<p>OFFICE OF ENVIRONMENTAL SUSTAINABILITY</p>
<p>INSPECTOR'S REPORT ON AN APPLICATION FOR A CERTIFICATE OF AUTHORISATION FOR A CLOSED LANDFILL</p>
<p>TO: Micheál Lehane, Director</p>
<p>FROM: Seán Byrne, Inspector Circular Economy Programme</p>
<p>DATE: 16 October 2023</p>
<p>RE: Application by Kerry County Council for a Certificate of Authorisation for a closed landfill at Ahascra Historic Landfill, Lisselton, Co. Kerry. Certificate of Authorisation Register Number H0194-01.</p>

Type of facility:	Closed landfill as defined in the Regulations ¹ .
Original site ownership	Kerry County Council.
Current site ownership	Kerry County Council.
Operator of closed landfill	Kerry County Council has operated this site since c.1975.
Proposed use post remedial works	Kerry County Council intends the site to continue to be used for cattle grazing and as agricultural storage and gravel compound.
Risk category of closed landfill:	High risk (Class A) due to <ul style="list-style-type: none"> leachate migration through surface water pathway (SPR8). The principal risk identified is the risk of leachate migration into the surface water drainage channel along the eastern site boundary.
Historic landfill

Figure 6: Groundwater flow direction and groundwater monitoring locations (BH)

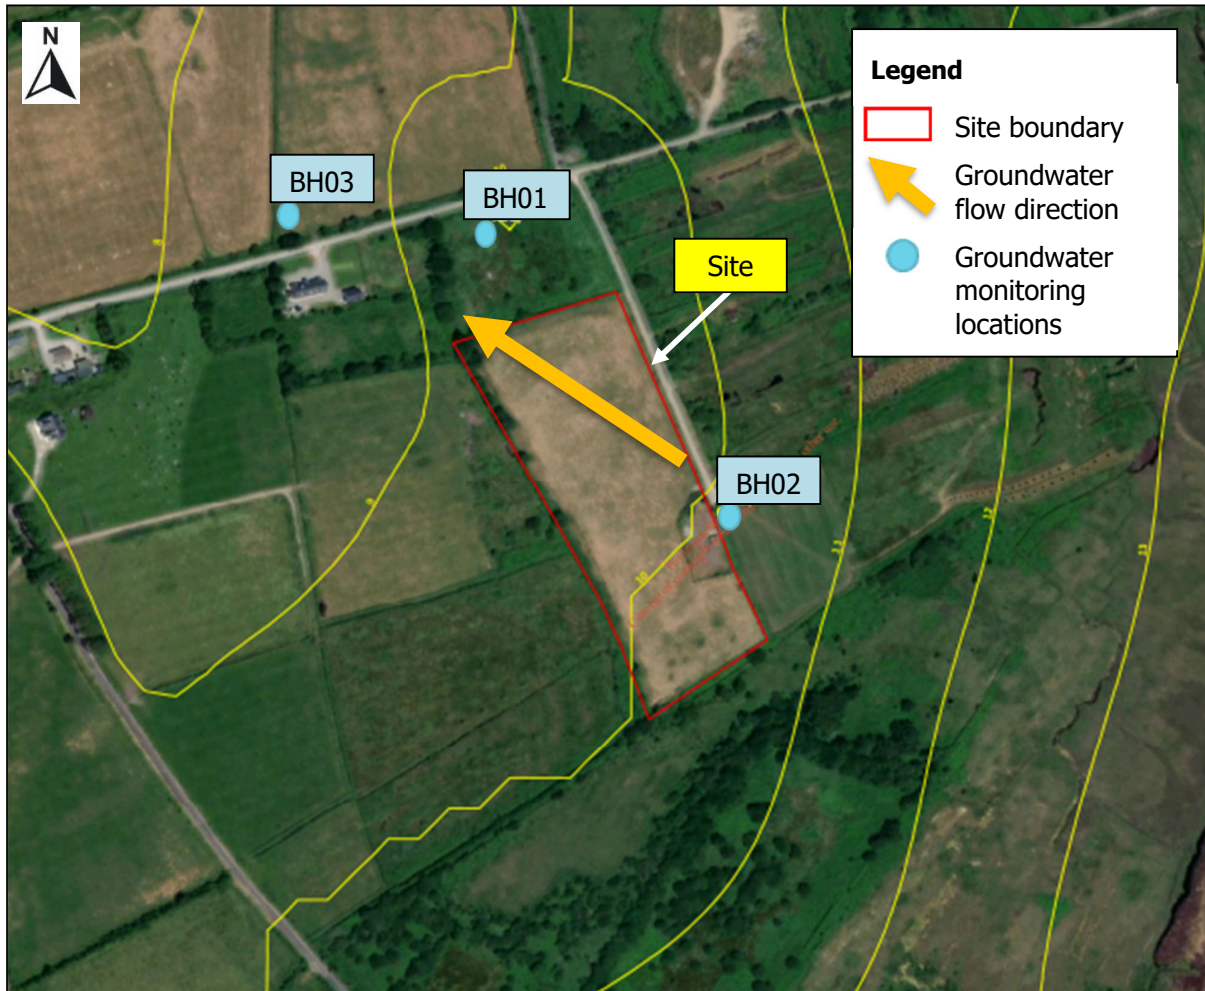
There were three rounds of groundwater monitoring at three monitoring locations in total, as shown in Figures 5, 6 and 7. Boreholes BH01 and BH02 (also referred to as BH-GW-01 and BH-GW-02) were monitored on 3rd September 2019, 16th July 2019 and 22nd November 2022. An additional borehole, BH03 was also monitored in November 2022. The table below outlines the information on the borehole profile and status encountered.

Groundwater monitoring was carried out on 22nd November 2022 at BH01, BH02 and BH03, as shown in Figures 5, 6 and 7. The table below shows the monitoring results.

The Tier 3 assessment recommends that annual groundwater monitoring be carried out at only two existing boreholes, BH01 (BH-GW-01) and BH02 (BH-GW-02). However, it is considered that groundwater monitoring at the three boreholes, BH01 to BH03, on a quarterly basis is appropriate and this is included in Condition 3.9(e) for the parameters set out in Schedule A.4.

Figure 7: Trial pit (TP), groundwater borehole (BH, BH-GW), gas borehole (BH, BH-GW and OLD-BH) and leachate borehole (LH) locations

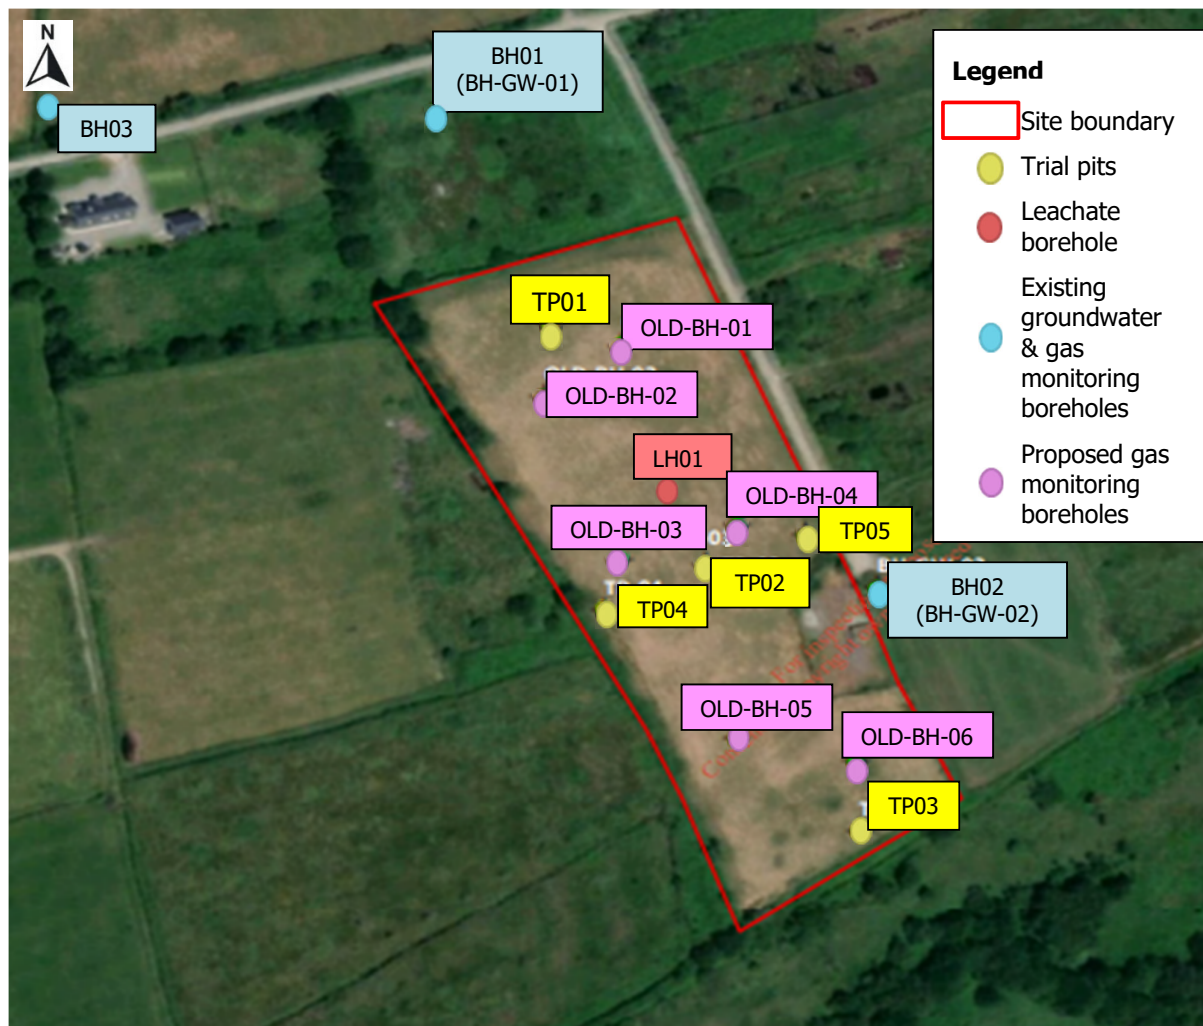
One leachate monitoring borehole LH01 was installed within the waste body, as shown in Figures 5 and 7, and described in the table below.

Leachate monitoring was carried out at location LH01 on 22nd November 2022, as shown in Figures 5 and 7. The monitoring results are shown in the table below.

<p>The monitoring results show no exceedances of the trigger levels for methane and carbon dioxide at monitoring locations outside of the waste body.</p> <p>There are six boreholes, OLD-BH-01 to OLD-BH-06, within the waste body which are serving as passive gas vents, as shown in Figures 5 and 7. No gas monitoring has been carried out at these boreholes to date. The Tier</p>	Monitoring Location Id	CH ₄ (% v/v)	CO ₂ (% v/v)	Trigger levels outside the waste body ¹		CH ₄ (% v/v)	CO ₂ (% v/v)	BH01	0.2	0.1	1	1.5	BH02	0.5	0.3
Monitoring Location Id	CH ₄ (% v/v)				CO ₂ (% v/v)	Trigger levels outside the waste body ¹										
		CH ₄ (% v/v)	CO ₂ (% v/v)													
BH01	0.2	0.1	1	1.5												
BH02	0.5	0.3

Tier 3 assessment recommends that the six boreholes shall be '*retained and sealed*' for gas monitoring rather than be utilised as gas vents and proposed instead one (new) passive gas vent for the site, as shown in Figure 9.1. Condition 3.1(d)(ii) requires the boreholes BH-OLD-01 to BH-OLD-06 be modified to accommodate gas monitoring.

Figure 9.1: Area to be capped

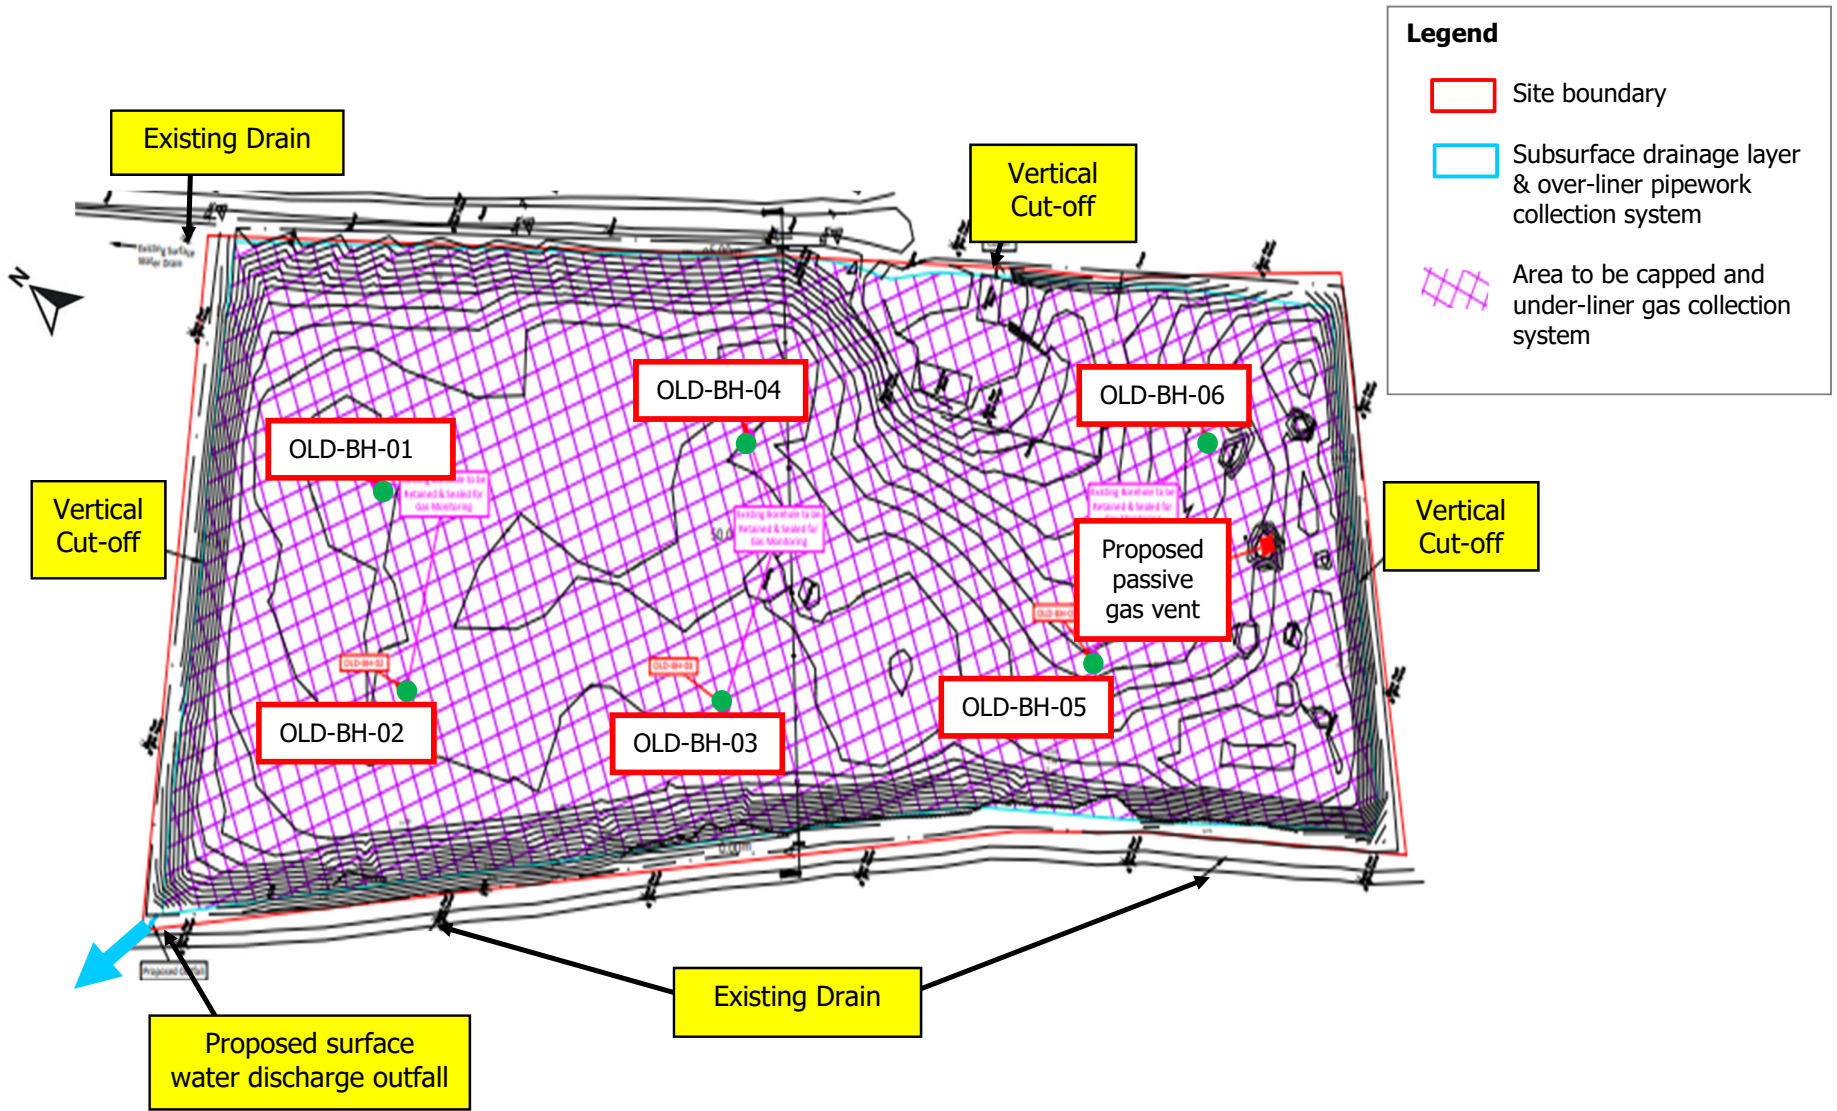
The Tier 3 assessment recommends that surface water be monitored annually at the outfall from the proposed site water drainage system, in the north-western corner of the site, as shown in Figures 5 and 9.1.

Condition 3.1(b) requires a gas drainage layer to be incorporated into the landfill cap. The Tier 3 assessment also states that '*gas management proposals shall carry out a gas management risk assessment (and) review and update as required the gas prediction model estimates... to inform the most appropriate landfill gas oxidation solution or venting as may be required.*' Condition 3.1(c) requires carrying out a gas risk assessment to inform the final design of the gas management system at the facility. Condition 3.1(c) further requires that the final design shall be in accordance with the EPA Landfill Manuals – Landfill Site Design and shall be submitted to the Agency for approval prior to implementation. Condition 3.1(d) requires the installation, operation and maintenance of a gas management system. This system shall include vertical gas vent pipes, biological filter, if approved by the Agency and any infrastructure as may be recommended by the findings of the gas risk assessment, as per Condition 3.1(c).
